FROM: Mitesh Baxi
Traffic Engineering

■ **CHIC-FIL-A [TRC Plan Review #2]**

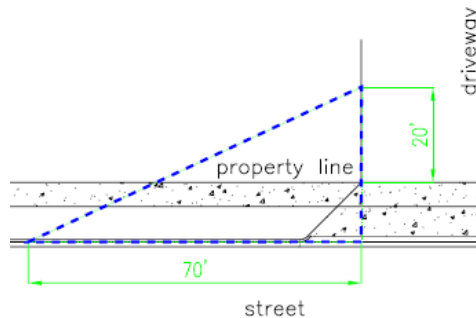
1. Show and apply the City's 20'x70' sight distance triangle at each driveways as per below image in site plan and landscape plan. [\[Sec.18-529\(c\) \(3\) CofW LDC\]](#) [\[Sec. 18-812 CofW LDC\]](#).
